City of Ryde Local Planning Panel Meeting No. 6/20

| 1 | 68-70 Chatham Road, Denistone - New multi-dwelling housing containing four (4) dwellings - 2 x 2 storey, 3 and 4 bedroom dwellings at the front and 2 x single storey, 3 bedroom dwellings at the rear as well as strata subdivision - LDA2018/458..... | 3 |
| 2 | 38 Wicks Road, North Ryde - Torrens Title subdivision to create two lots and construction of a dwelling house on each resulting lot - LDA2019/0411 | 63 |

City of Ryde Local Planning Panel Report

Figure 16: Extract of ground floor plans showing internal privacy impacts
Source: Architectural plans

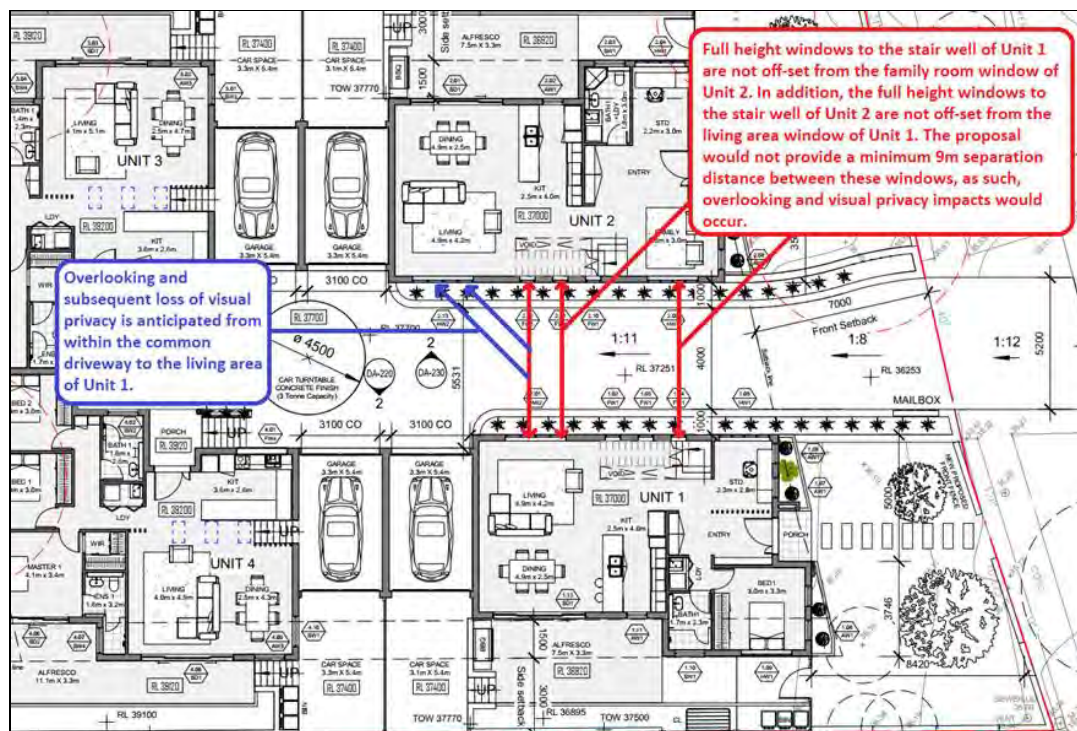
The stairs of Dwelling 1 and 2 have direct views into the respective living and family rooms. Further the sill height of the living room windows of Dwelling 2 is less than 1.5 metres high and this window faces onto the common driveway. The above will result in unacceptable privacy impacts between dwellings (**Figure 16**).

Additionally, the excessive cut and fill arrangements result in poor design outcomes when trying to limit overlooking to adjoining properties. For example, in order to maintain visual privacy, a 1.8 metre boundary fence on top of a 1.12 metres high retaining wall is proposed along the southern boundary of Unit 4. This adversely impacts on the visual outlook of No. 66 Chatham Road whereby a boundary fence height of up to almost 3 metres is provided at the private open space of No. 66 Chatham Road. Alternatively, if an overall fence height of 1.8 metres was utilised (when measured from EGL at No. 66 Chatham Road), this would result in direct overlooking into the rear private open space of No. 66 Chatham Road given the raised deck and ground floor level of Unit 4. This poor design outcome is a direct result of the site's unsuitability for multi dwelling housing because of the gradient, and the poor design response to the site constraints.

Figure 17: Extract of Tree removal and retention plan

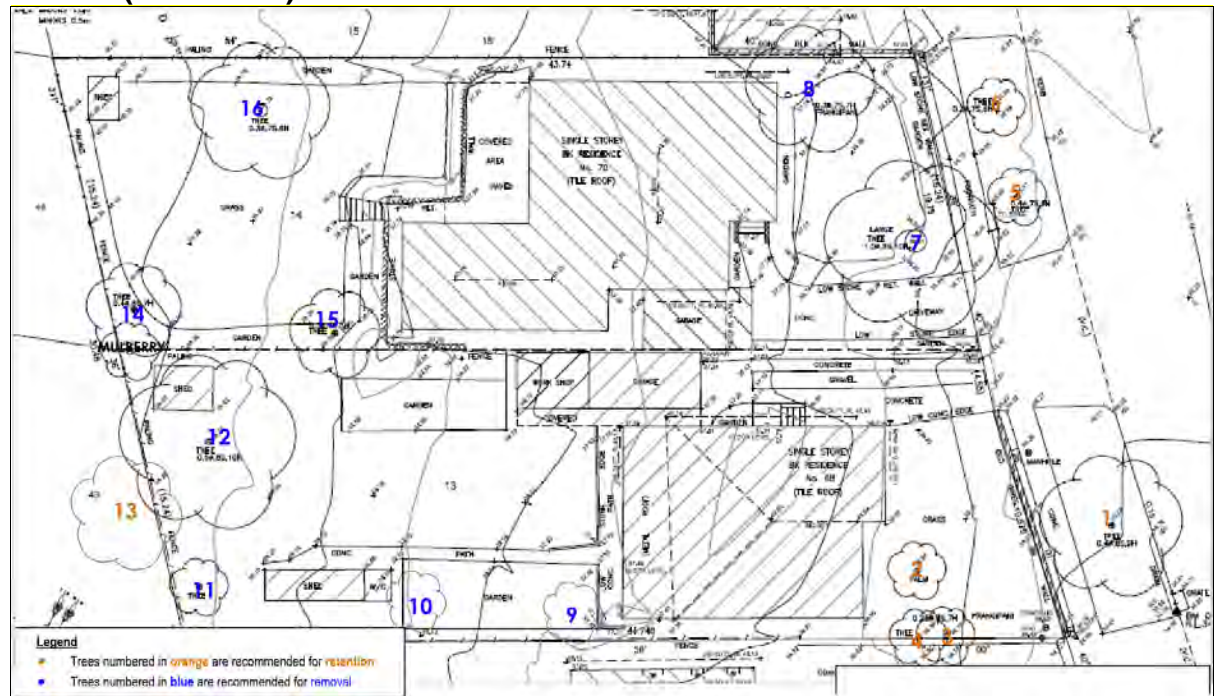
- The proposed removal of nine (9) trees (Trees 7, 8, 9, 10, 11, 12, 14, 15 and 16) is supported as they are not considered capable of being retained due to the unacceptable and unavoidable impacts from the proposed construction works. The removal of these trees will result in a low to moderate impact to the landscape character of the subject site and replacement planting is required.
- The retention of three (3) trees on site (Trees 2, 3 and 4) is supported. The retention of three (3) Council street trees (Trees 1, 5 and 6) will require referral and approval from Council's Tree Management Team prior to any consent being granted. However, given their location away from the proposed construction works, they are unlikely to be impacted.

Figure 10 – The north-western corner of the dwelling which is elevated.

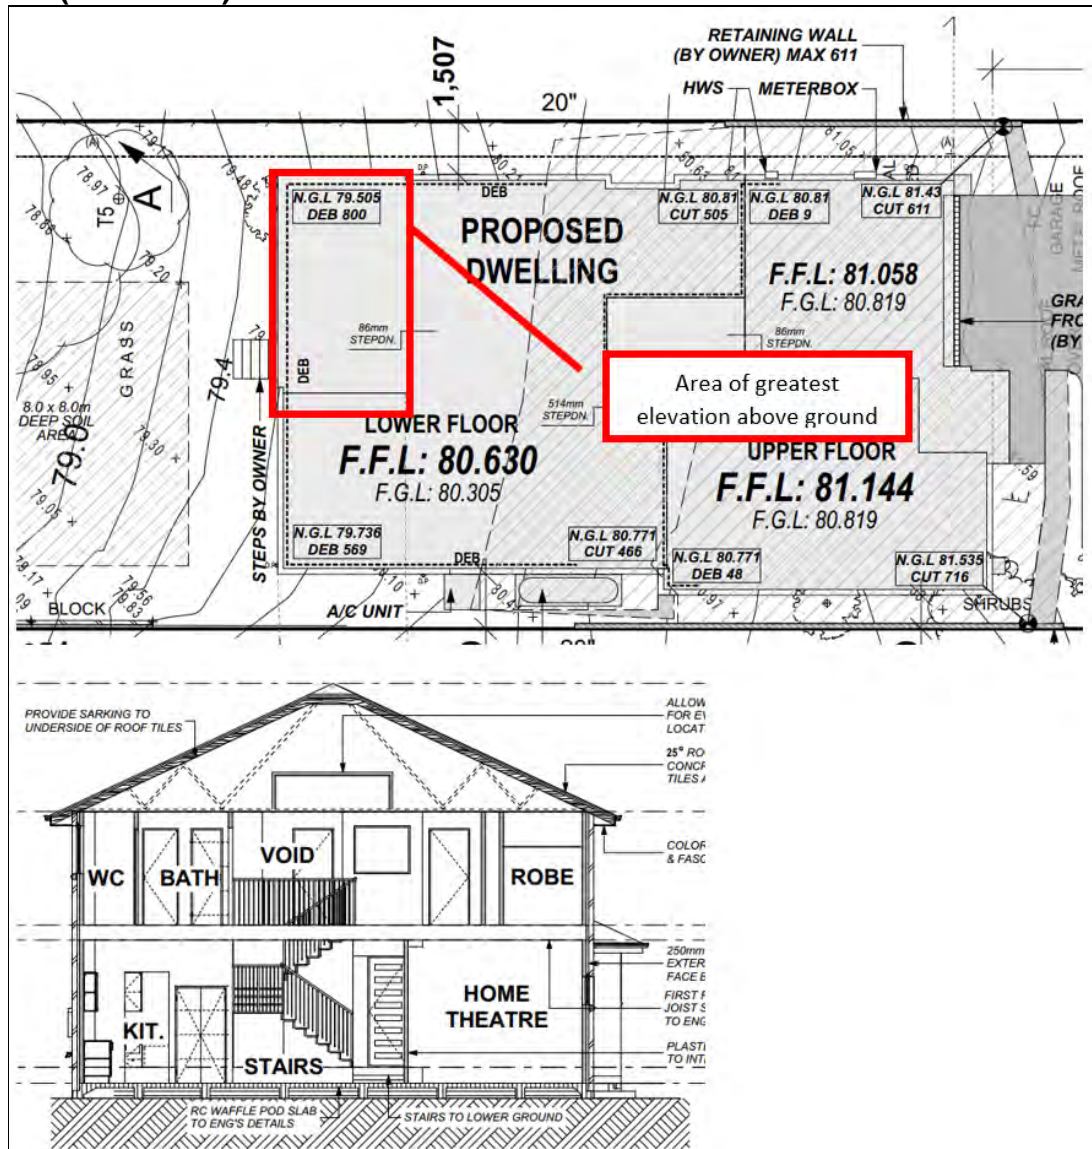
corner of the dwelling on Lot 2 (alfresco area) would be significantly elevated 1140mm above ground level (**Figure 10**). Whilst the area under the rear of this dwelling would not technically be 'filled', it would present the appearance of a structure that is built above natural ground level and the existing landform of the site.

The relevant objectives of the controls would be satisfied, in that the proposed development has for the most part retained ground levels and landform and would minimise the extent of excavation and fill; as the issue is at the rear of the site, there would be no impact on streetscape.

Figure 11 – The proposed side setback of 950mm from south-western side boundary
Source: Hart & Home 2020

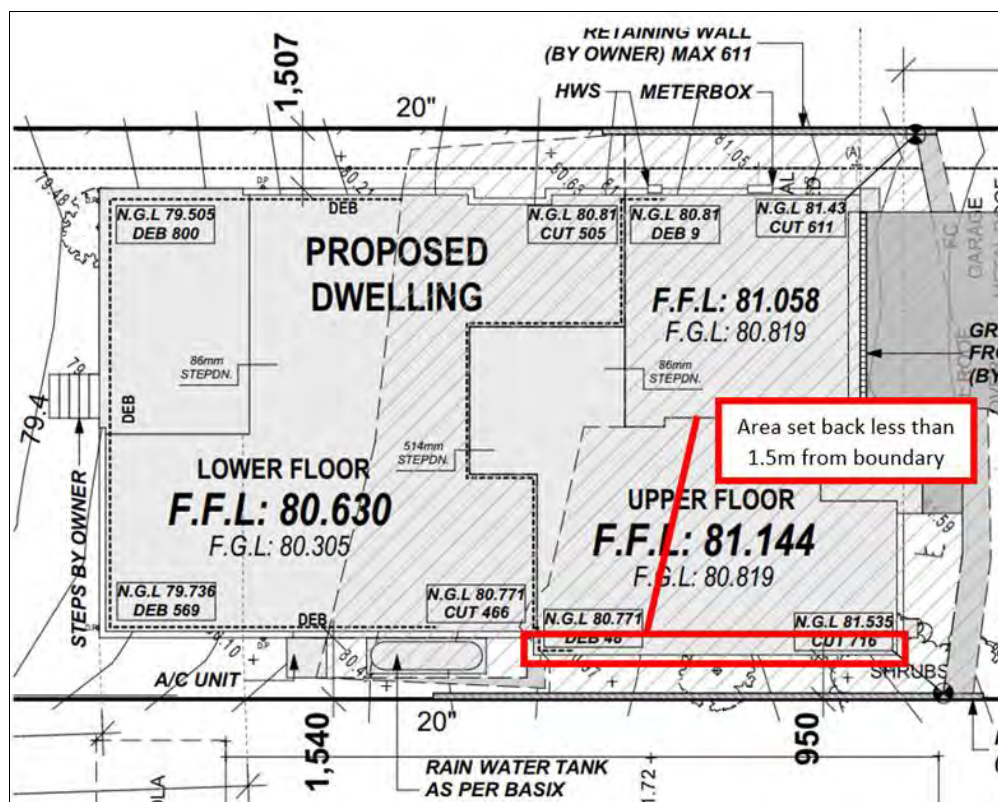
Control (b) requires 1.5 metre side setbacks for two storey dwellings. The proposed dwelling on Lot 1 is compliant with this requirement. However, the proposed dwelling on Lot 2 is set back 950mm from the south western side boundary (Figure 11) and does not comply. The proposal is considered acceptable for the following reasons:

- The extent of non-compliance along the south western elevation is for a length of 7.38 metres. The remainder of the elevation provides for a 1.504 metre setback and complies.
- The non compliance occurs at ground floor with the first floor complying with the required setback.
- The rear of the dwelling where it is elevated achieves a compliant side setback.
- The elevation contains a single window associated with the ensuite and does not result in any adverse privacy impact upon the adjoining dwelling at 36A Wicks Road.
- The non compliant setback does not result in any unacceptable overshadowing to the adjoining dwelling.

On this basis, the minor variation is acceptable.

Figure 13 Tree 3 and 4 proposed for removal Source: Hart & Home 2020

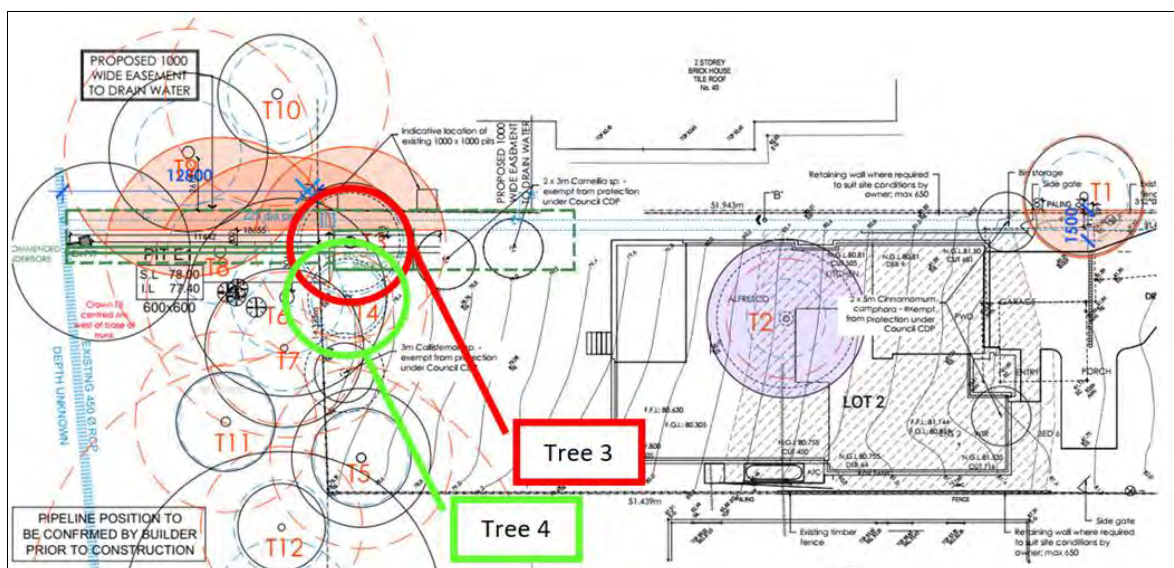
The proposal also includes the removal of Tree 2 (Gordonia) which is sited within the building footprint of Lot 2. The submitted landscape plan additionally shows the removal of Tree 3 and 4 (Chinese Weeping Cypress and Ash Tree) (**Figure 13**). The proposed removal is necessary to accommodate the proposed underbore stormwater pipe to the North Ryde Golf Course. Compensatory tree planting or two local Australian native trees with a minimum pot size of 45 litres has been recommended by way of consent conditions.
